ADDENDUM #4

February 25, 2011

Re: Harrisburg Area Community College
Public Safety Center – Law Enforcement Complex & Site Improvements
Solicitation # 11-13

From: Eastern PCM, LLC
Construction Manager – HACC
645 N. 12th Street, Suite 200
Lemoyne, PA 17043

SCALE: AS SHOWN
 DATE: FEB. 24, 2011
 K&W PROJECT: 2091.001
 DRAWN BY: ROE
 CAD DRAWING: 2091001-I_cadd115.dwg
 SHEET: **SC-15**

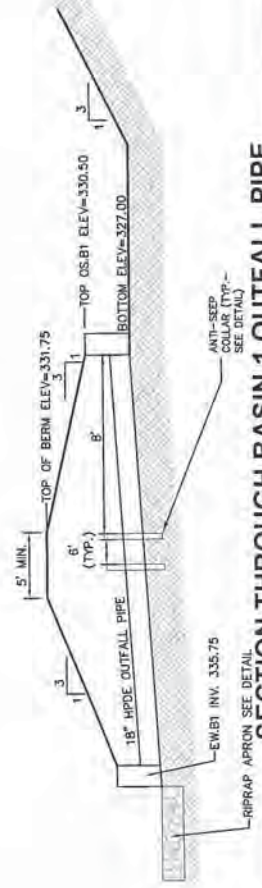
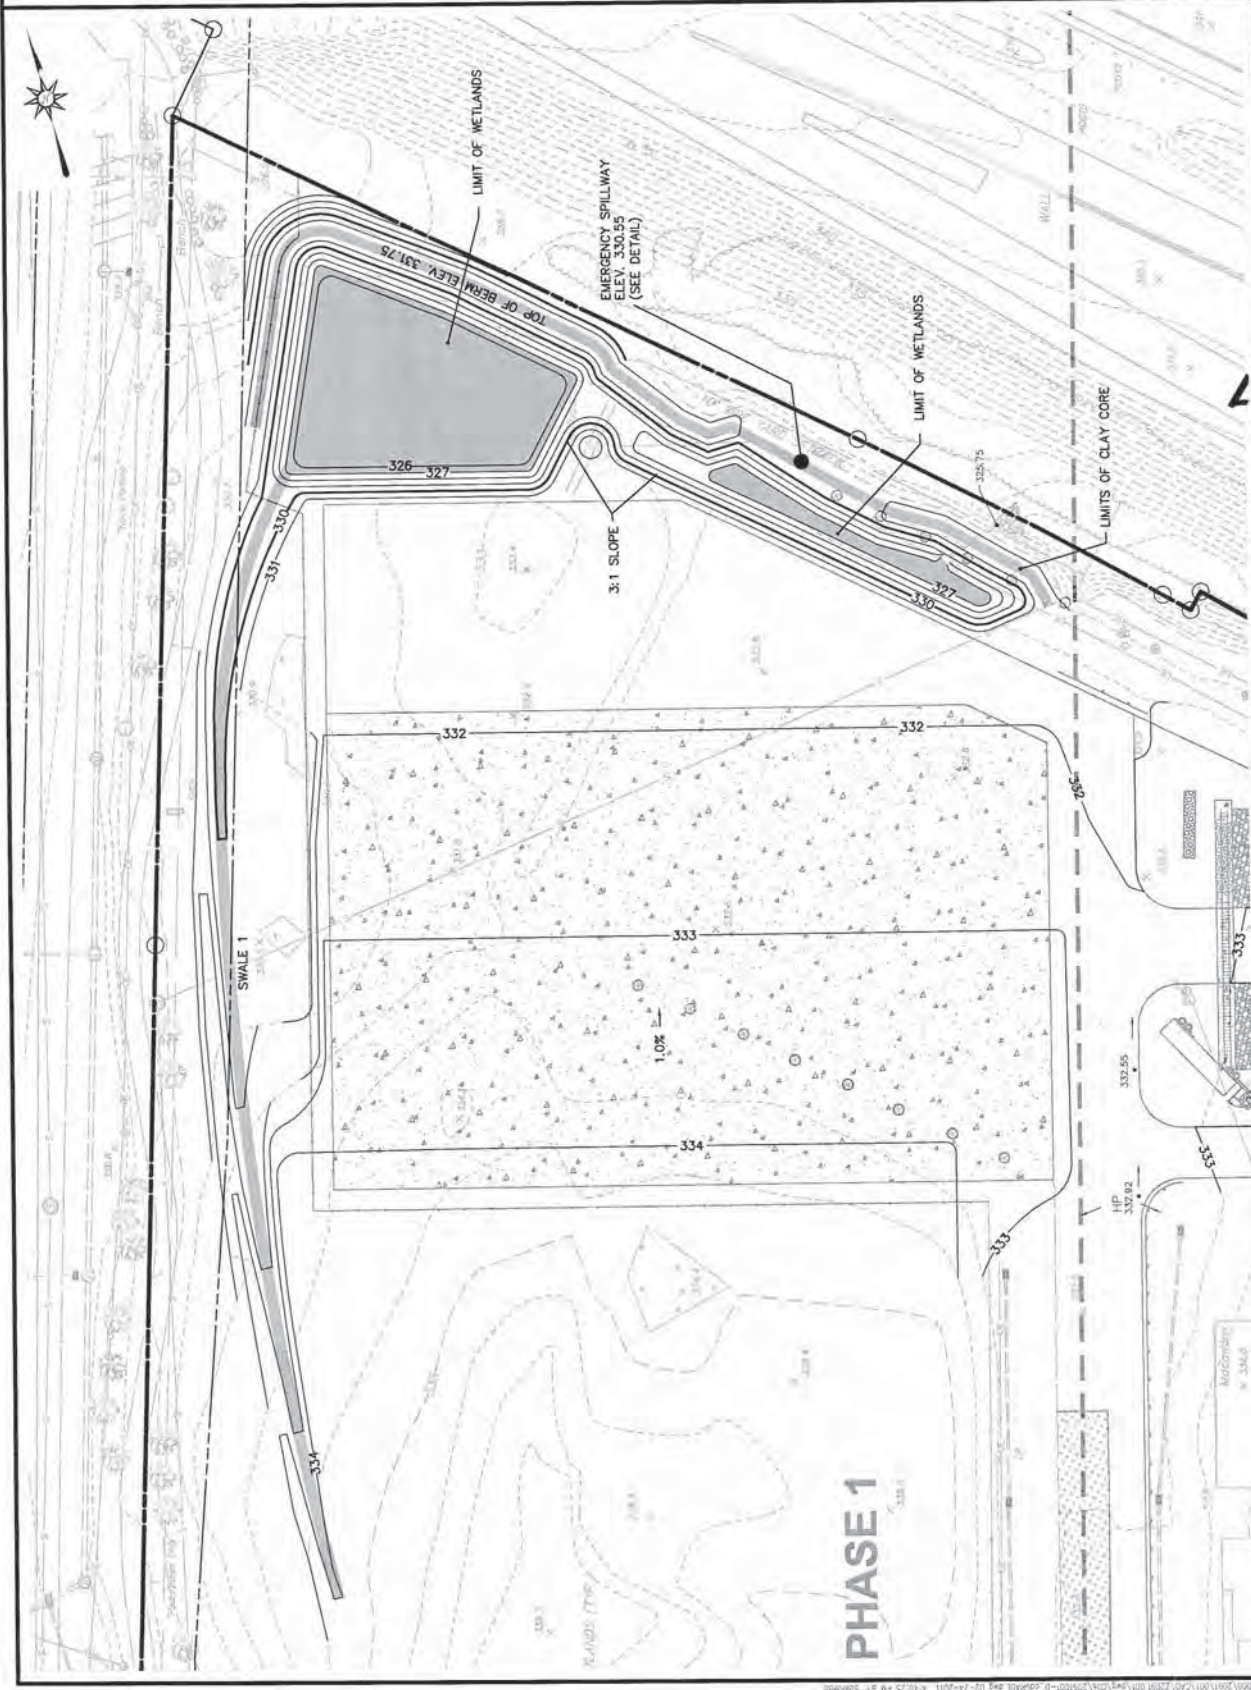
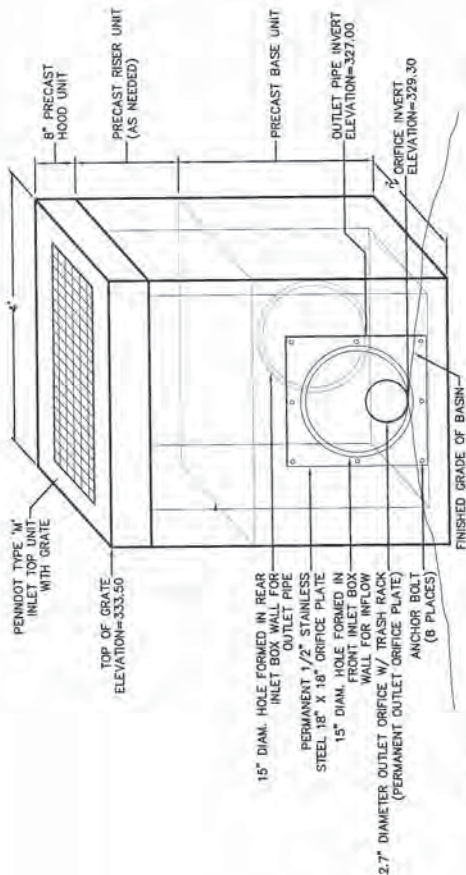
ADDITIONAL NOTES:
 1. MODIFIED BASIN 1 DIMENSIONS
 2. ADDED WETLANDS
 3. LINE BOTTOM OF SWALE 1 TO CLAY TO LIMITS SHOWN.

23
MA5.2
DUCT ROOF PENETRATION AND SUPPORT DETAIL
NO SCALE

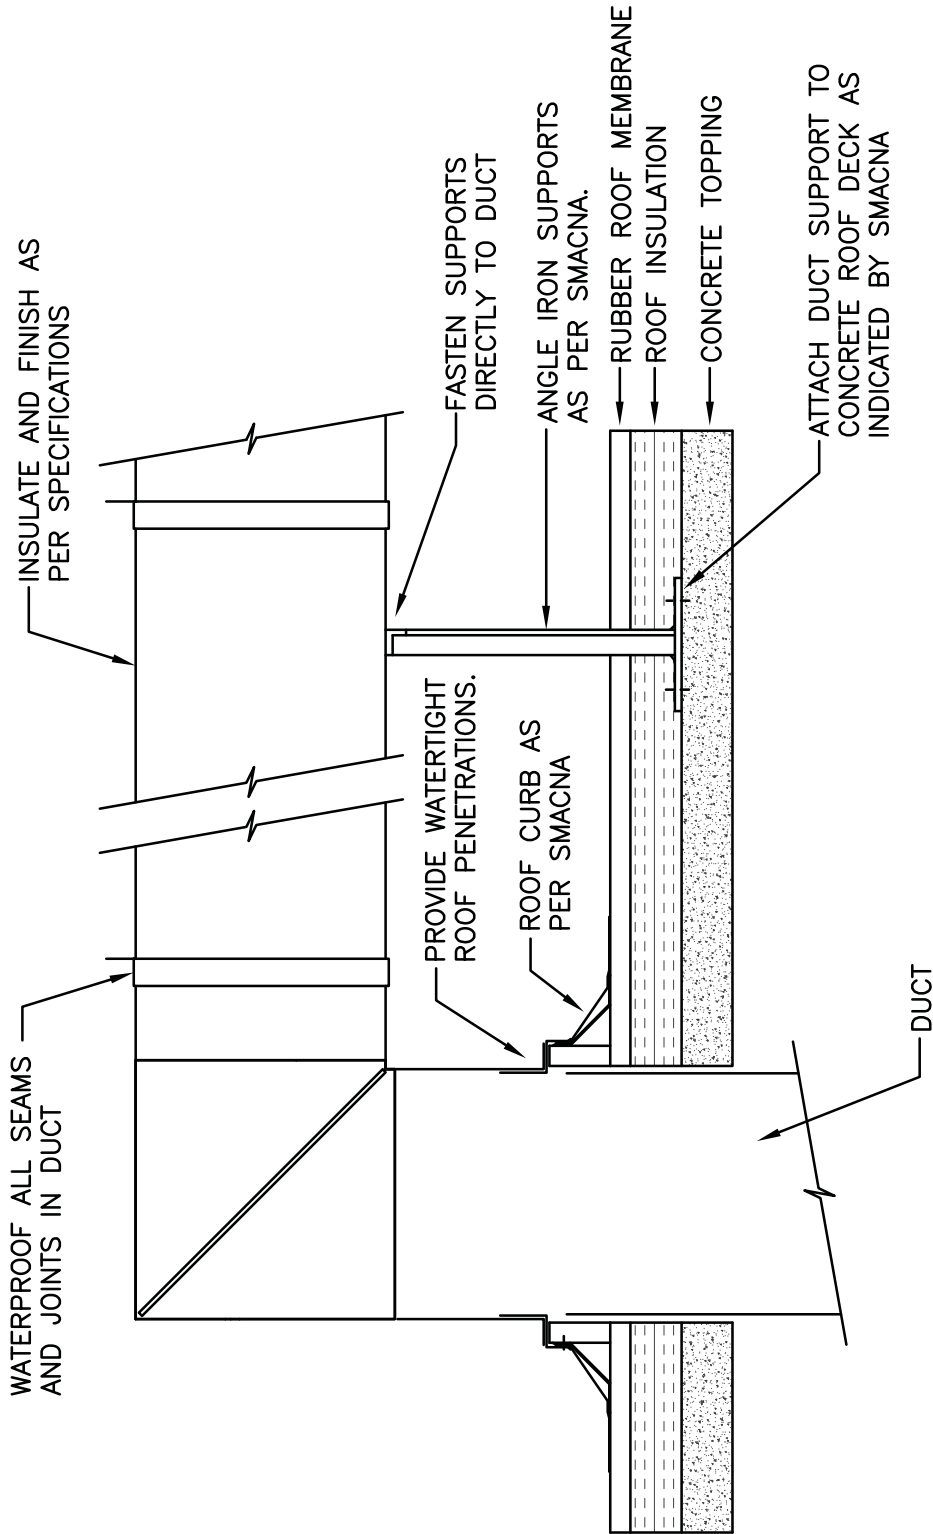
- W. Drawing MA5.2: ADD Detail #23 – duct roof penetration and support detail sketch SK-MA5.2-1, attached to this addendum #4.
- X. Drawing PA5.2: CLARIFICATION: On Detail 7 Vent Thru Roof, it is acceptable to use rubber flashing compatible with the roofing system in lieu of lead shown.

- A:** EMT is acceptable in the firing range.
- EE. **Q:** Is there a Detail to how to support the roof duct?
- A:** SK-MA5.2-1 is applicable for all roof duct supports.

PROJECTION SCREEN WIRING DIAGRAM (TYP)

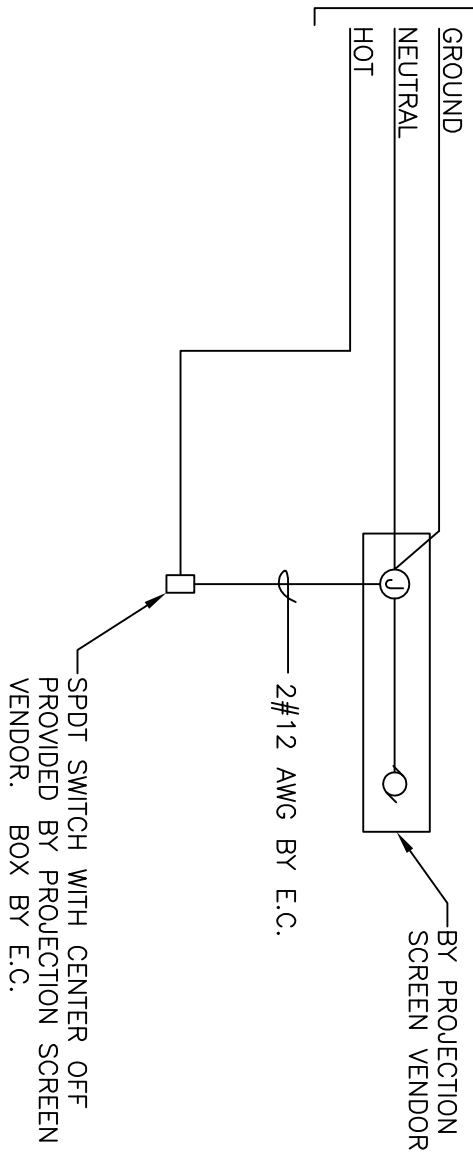
- BB. Drawing EA5.4:
- a. ADD projection screen wiring diagram sketch SK-EA5.4-1, attached to this addendum #4.
